Tier 2 Motor Vehicle Emission Standards and Gasoline Sulfur Control Requirements: Response to Comments

Engine Programs and Compliance Division
Office of Mobile Sources
U.S. Environmental Protection Agency

RESPONSE TO COMMENTS DOCUMENT
TIER 2 MOTOR VEHICLE EMISSION STANDARDS AND
GASOLINE SULFUR CONTROL REQUIREMENTS

Figure 1.

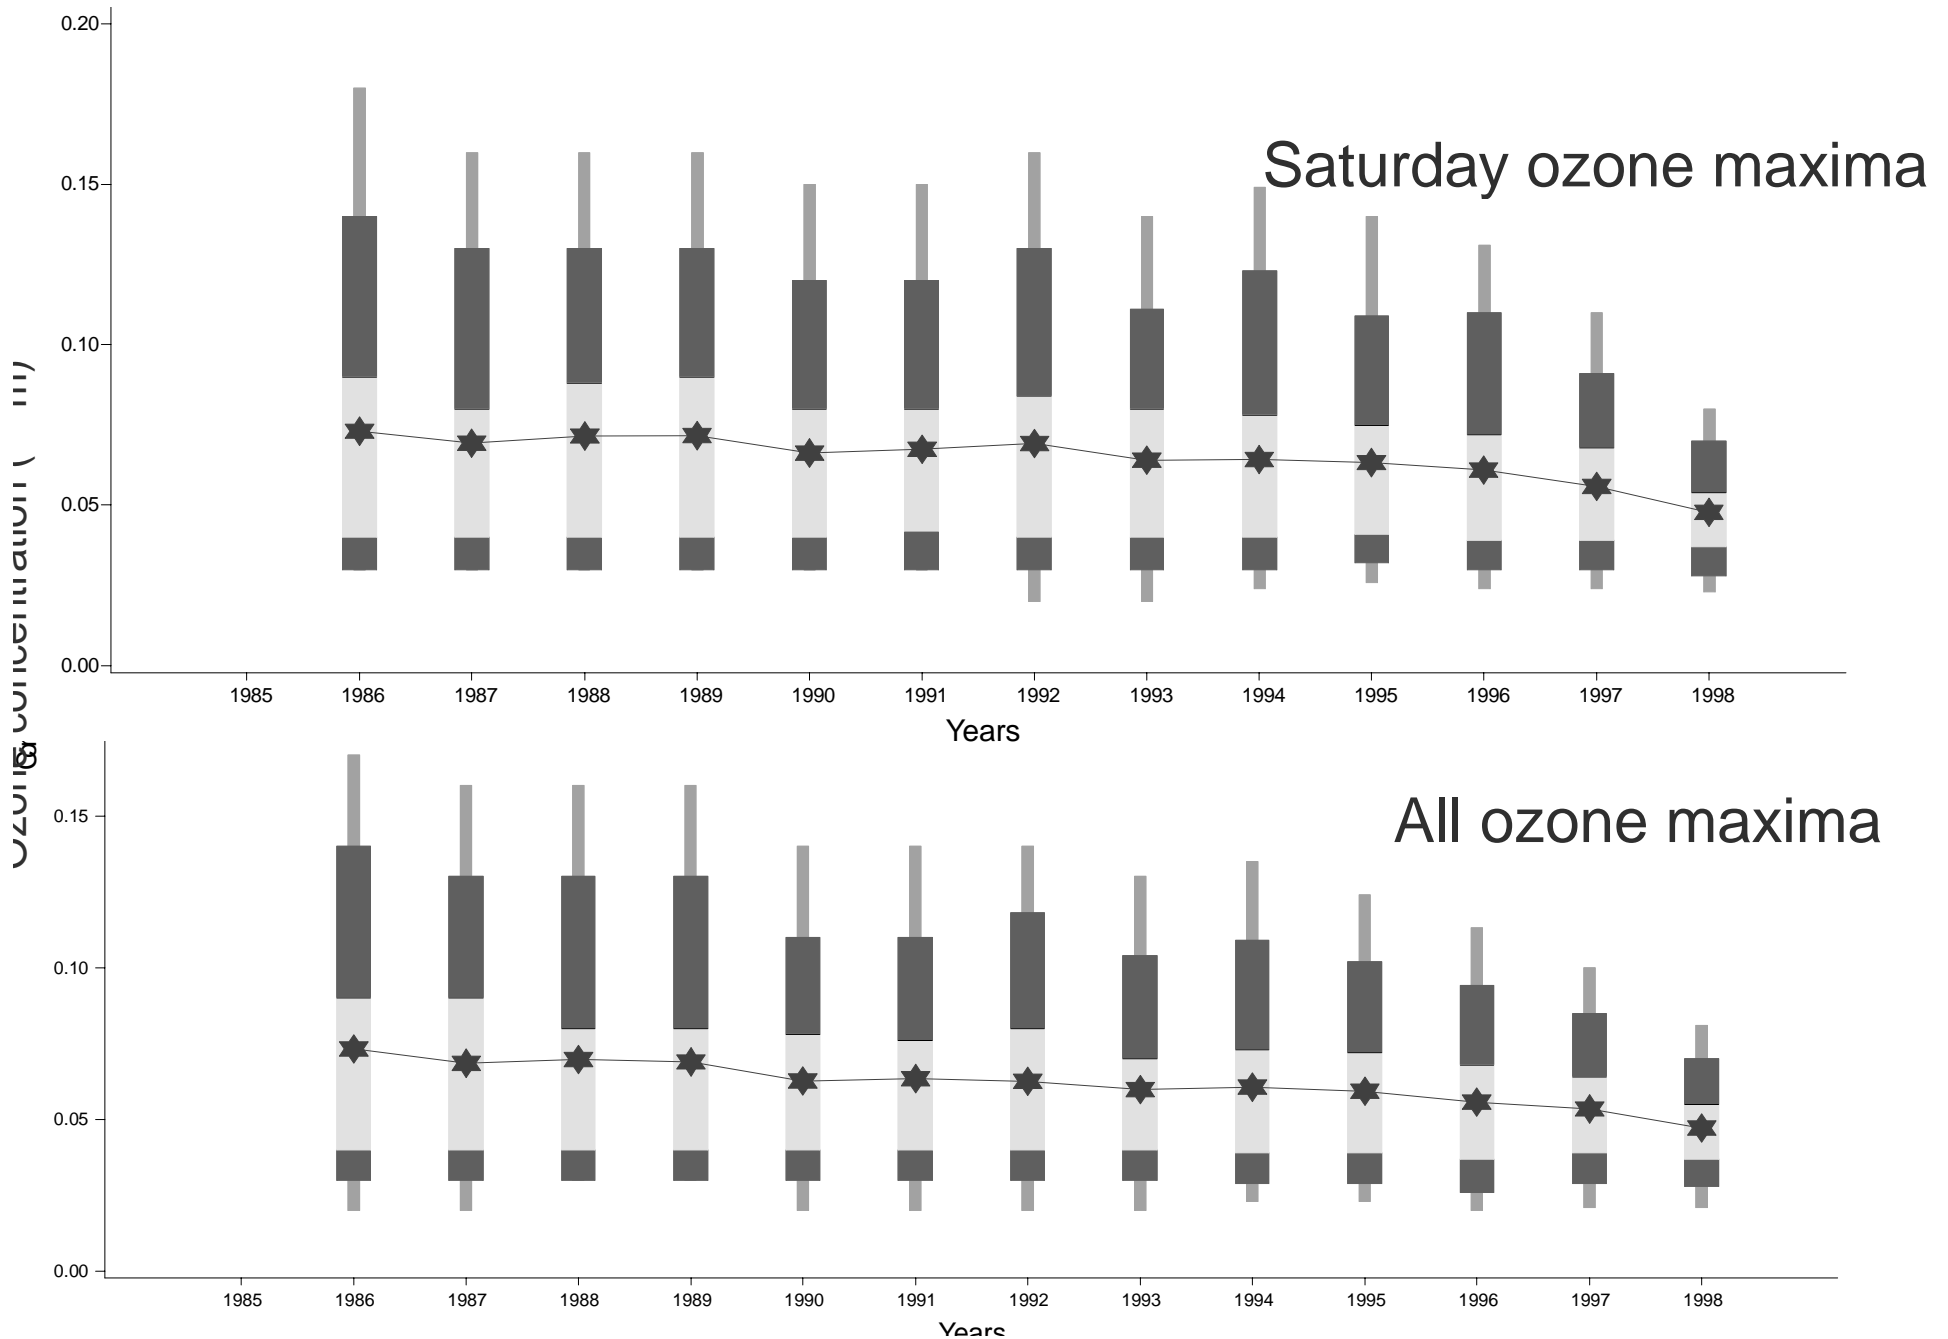
Figure 1: Long-term trends in Ozone and Emissions: Reductions in ozone maxima for L.A. Basin occur during a period of reductions in NO_x (and VOC) emissions.

Figure 2.

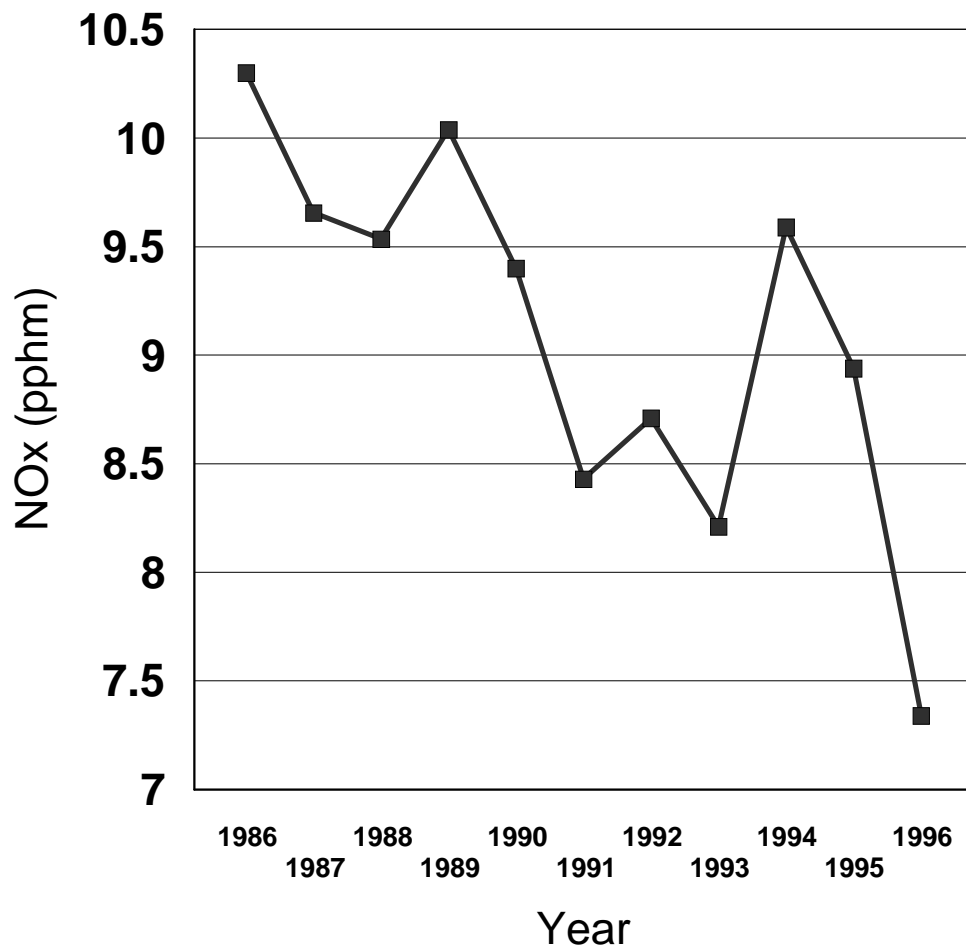
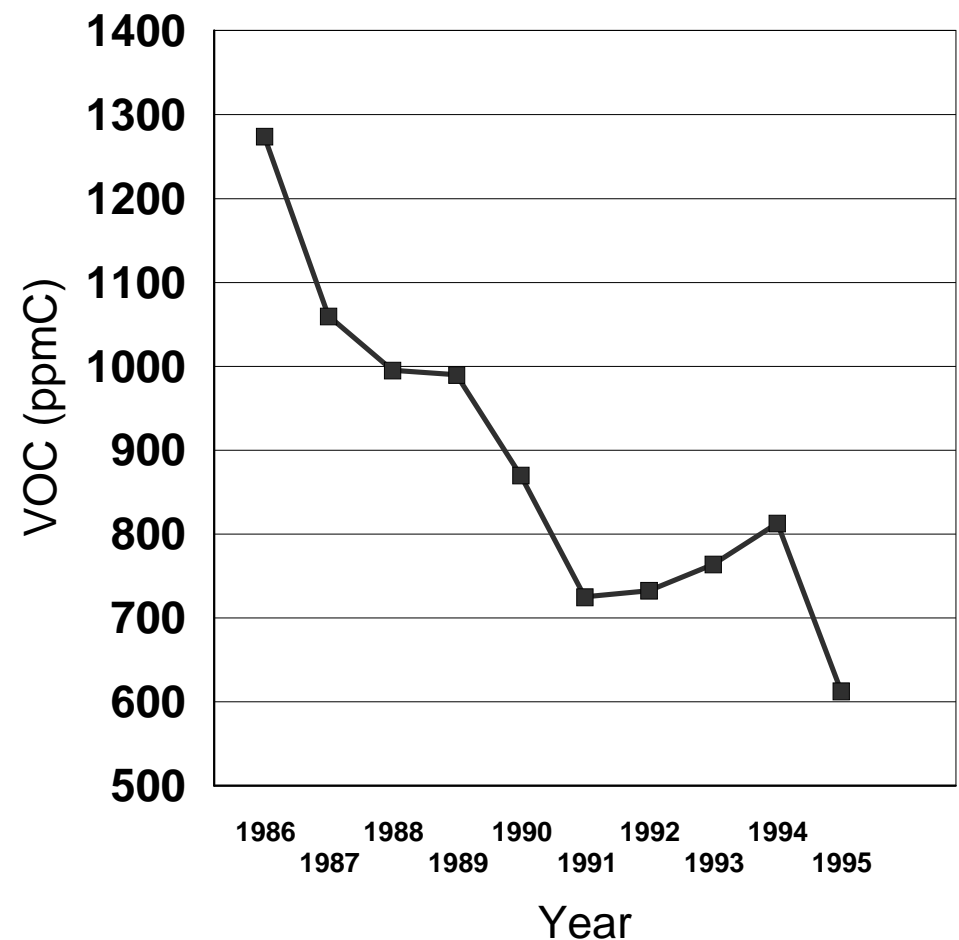
Figure 2: Ambient trends in L.A. Basin suggest morning NO_x and VOC (mobile related) emissions have decreased significantly over the period of declining ozone.

Figure 3.
Findings of Regional Weekday/
Weekend Effect in OTAG by Husar

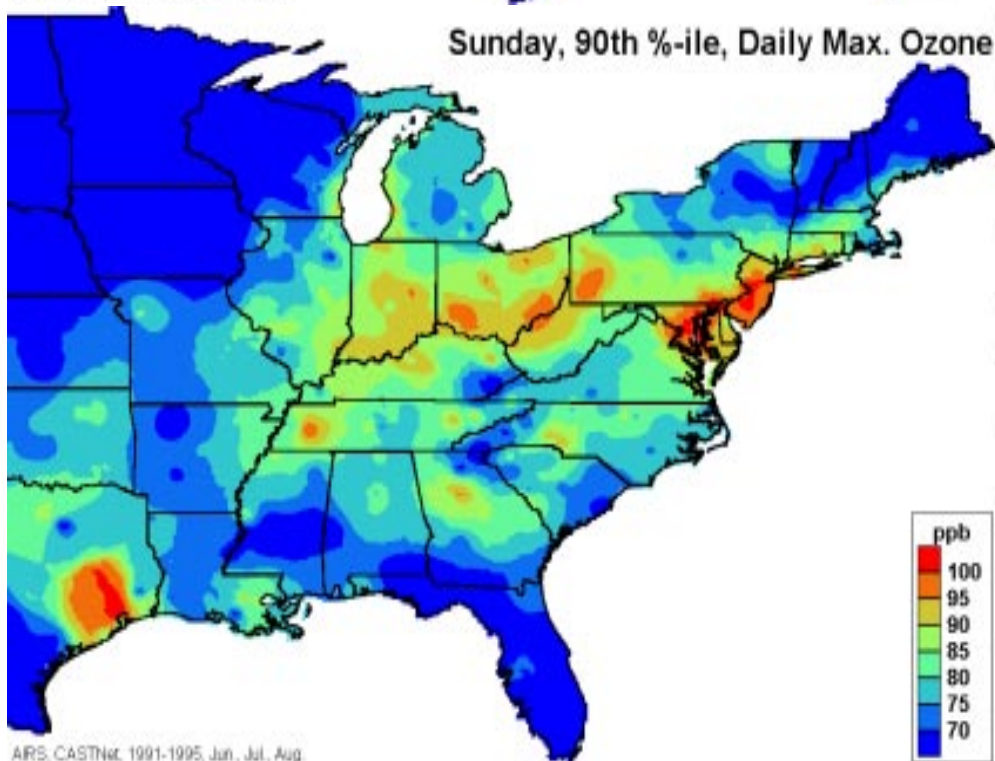
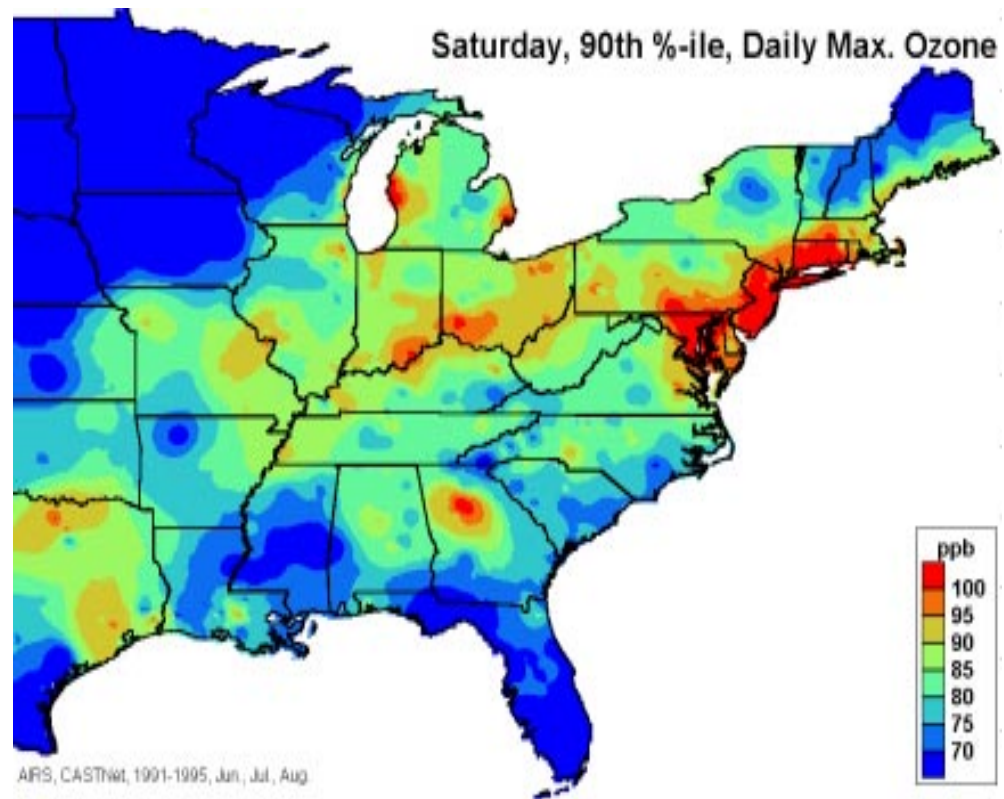
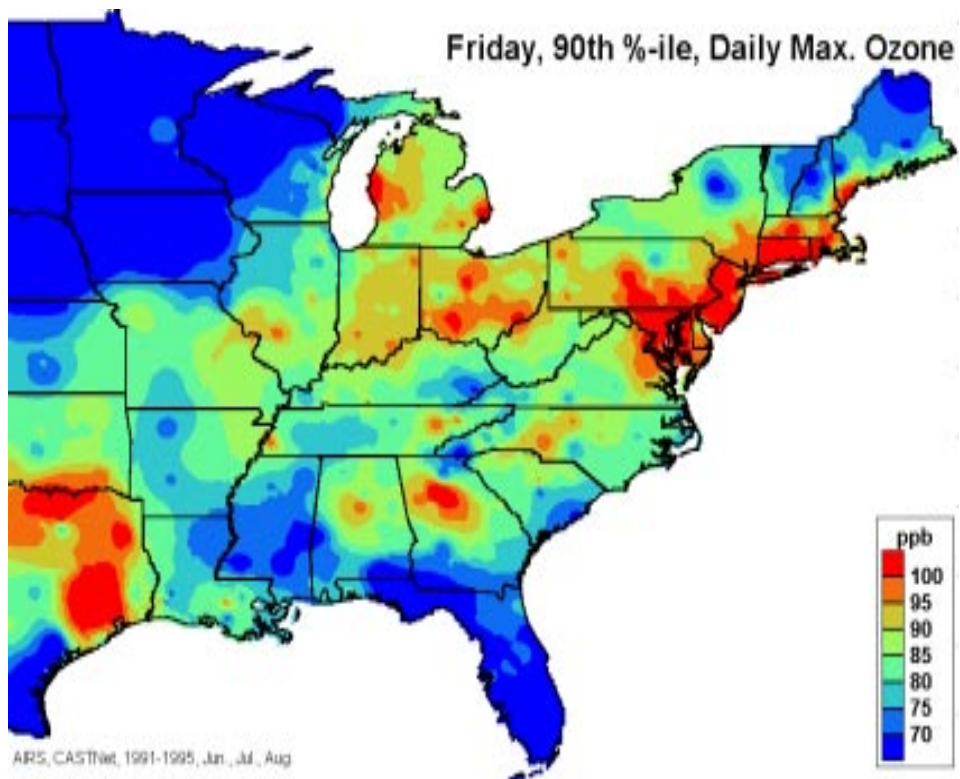
Figure 3: Findings of Regional Weekday/Weekend Effect in OTAG by Husar.
